### **Plan Change 60 - Maxwell Hills Zone – Reply to Request for Further Information**

**RESPONSE TO REQUEST FOR  
FURTHER INFORMATION  
RESOURCE CONSENT  
APPLICATION  
PLAN CHANGE 60 - MAXWELL  
HILLS ZONE**

The following responses, prepared by Riley Consultants Ltd (RILEY), relate to questions raised by Mr Paul Whyte of Beca Carter Hollings & Ferner Ltd (Beca) on behalf of the Marlborough District Council (MDC), in their letter dated 10 June 2011, requesting further information.

TITLE  
**KAPITI VIEWS LTD.**  
**RURAL RESIDENTIAL DEVELOPMENT - PRIVATE PLAN CHANGE**  
**STORMWATER NETWORK PLAN - SHEET 2**

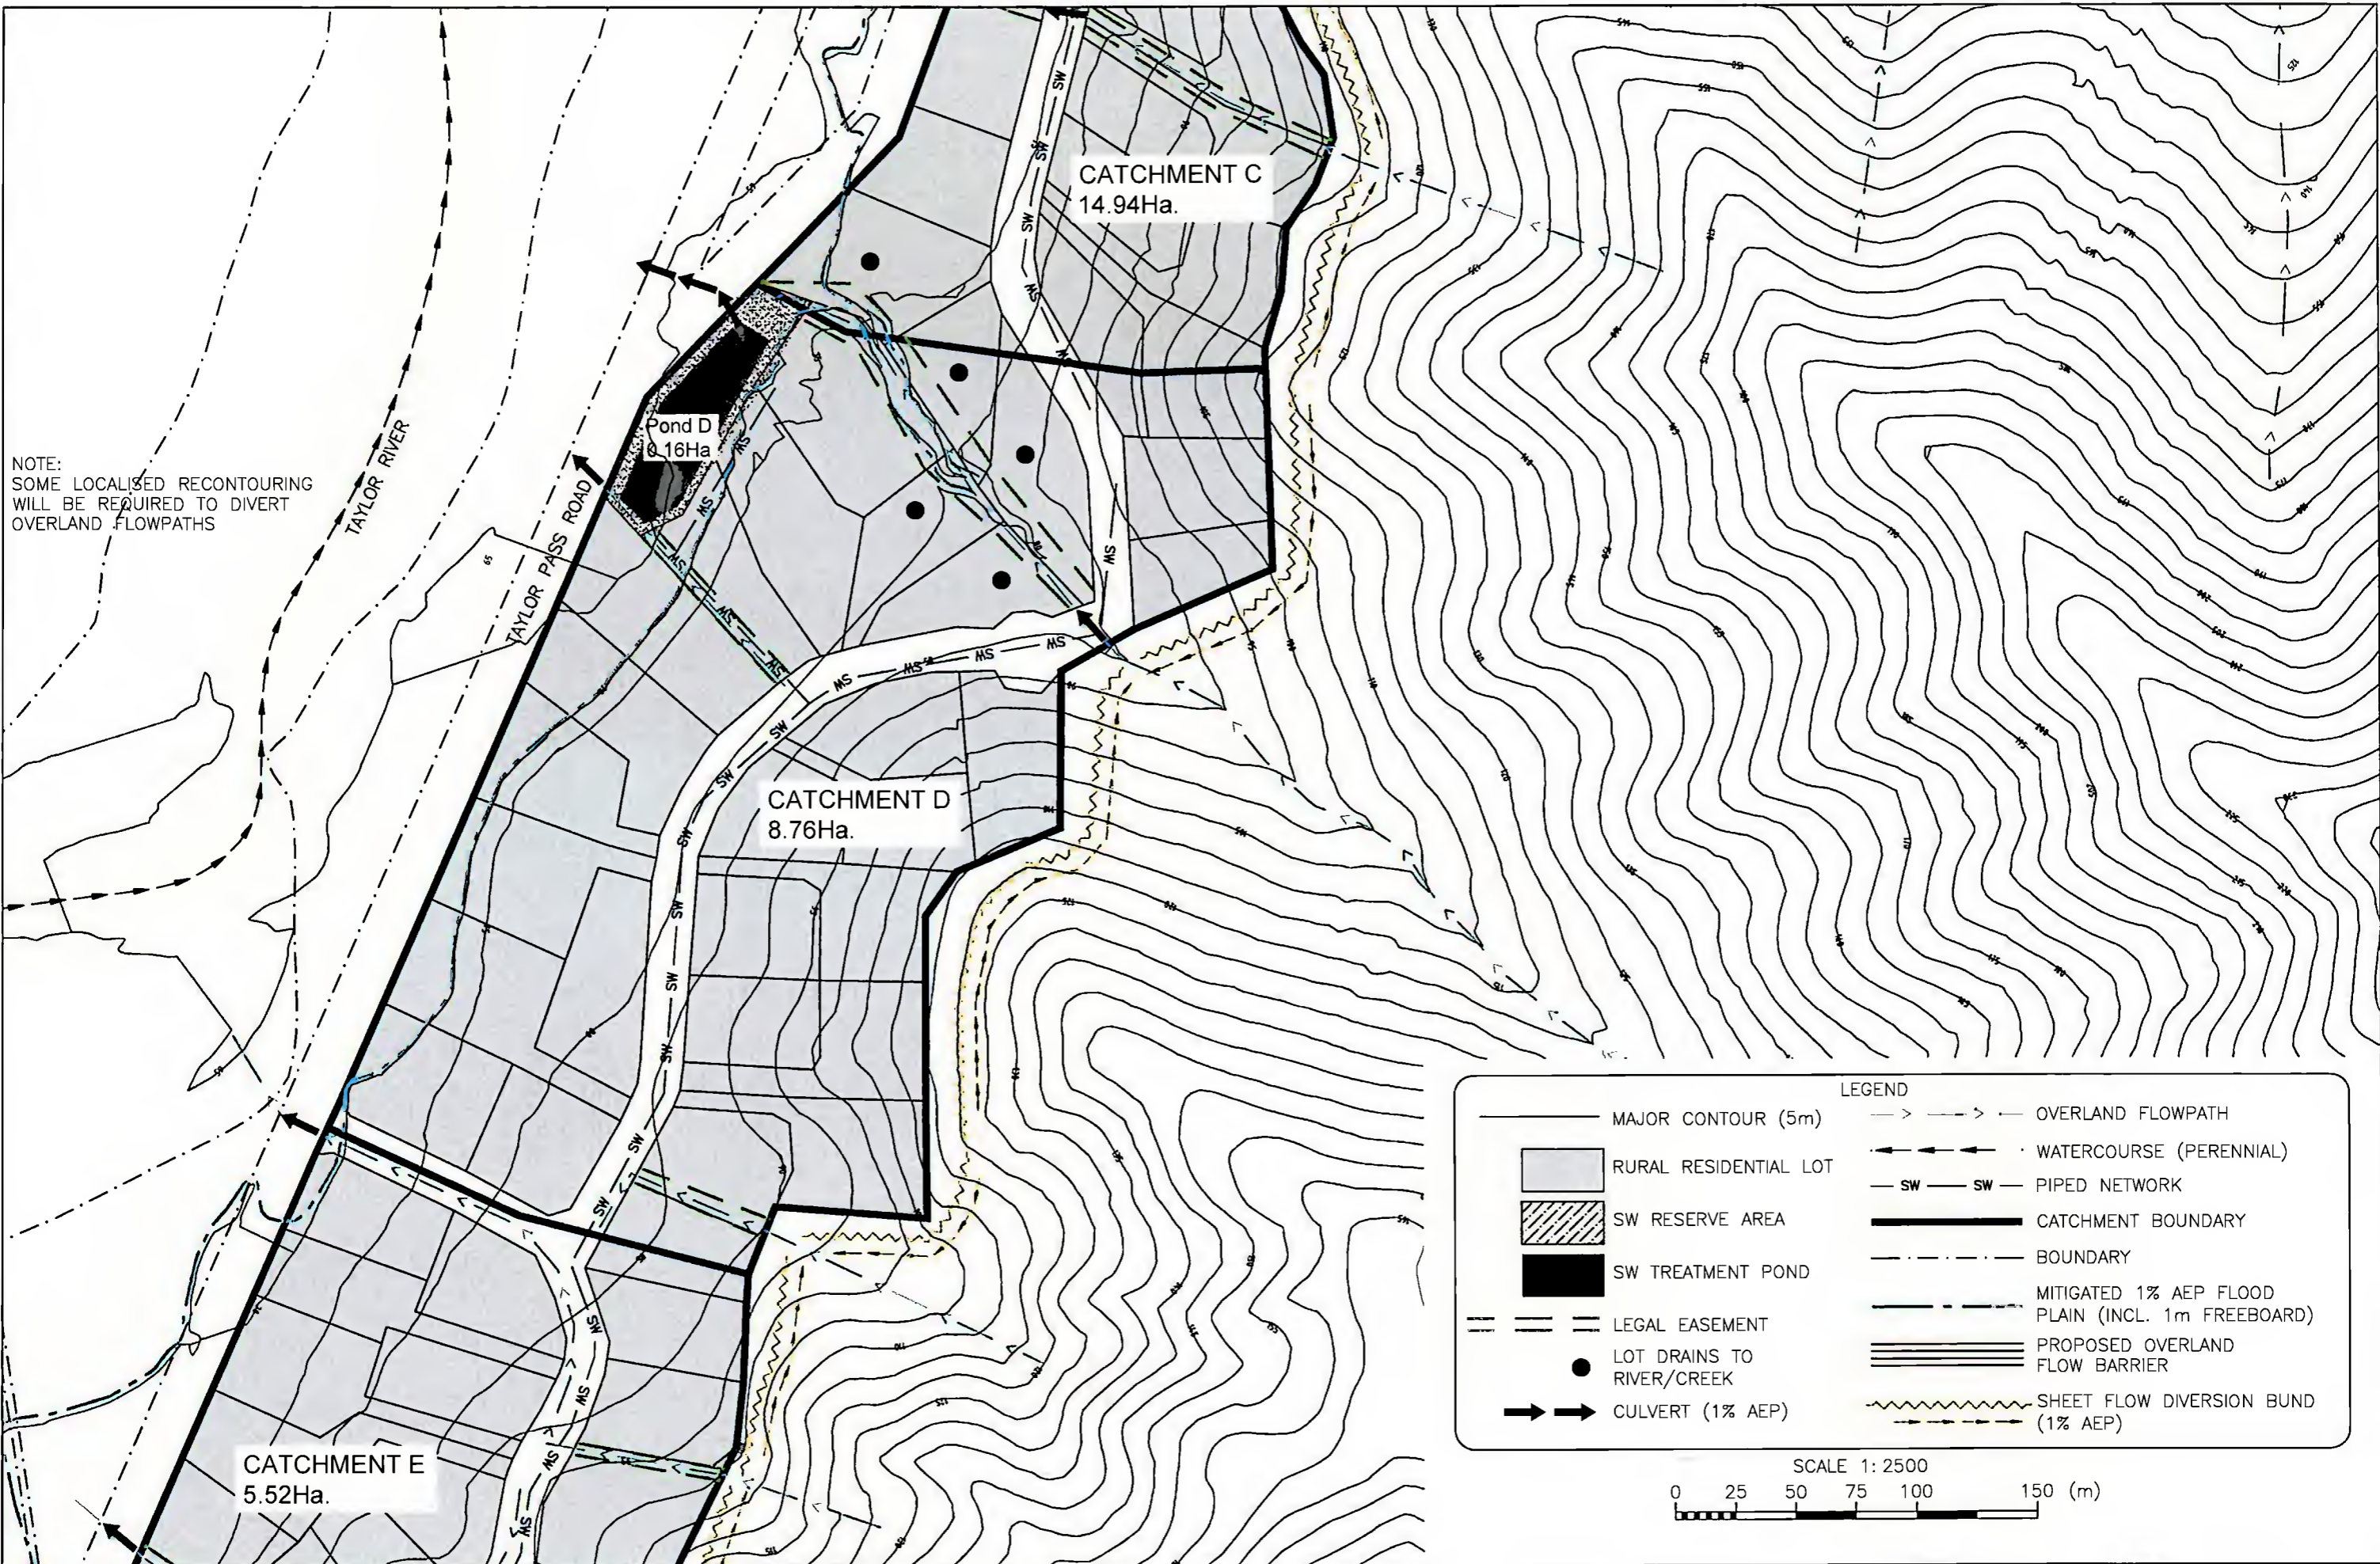
### **Reply to Additional Comments from Mr Brin Williman**

Provision for runoff from the catchment above the plan change area, should be made to allow existing overland flow to continue through the developed area as shown on RILEY Dwgs: 04819/6SW-1 to 4. A number of overland flowpaths have been identified with water passing along roads or easements created along residential boundaries. All stormwater runoff from the catchment above the proposed plan change area will bypass the piped network and treatment ponds. Stormwater from the upper catchment will cross the road network either through a culvert for up to the 1% AEP event or as overland flow via localised depressions in the road network. Overland flow from the upper catchment will ultimately discharge directly to the Maxwell Creek or Taylor River.

As shown on the RILEY Dwgs: 04819/6SW-1 to 4, five water quality ponds (labelled A to E) have been included in the stormwater network. The ponds have been designed in accordance with Auckland Regional Council Technical Publication No.10, 'Stormwater Treatment Devices Design Guidelines Manual', Second Edition, May 2003 (TP10), as prescribed in the MDC Code of Practice. The preliminary pond sizing has been calculated based on the preliminary development scenario for the proposed plan change area as shown on RILEY Dwgs: 04819/6SW-1 to 4. The pond sizing includes for impervious areas (i.e. roads, roof, and private hardstand areas) and are summarised below in Table 2.
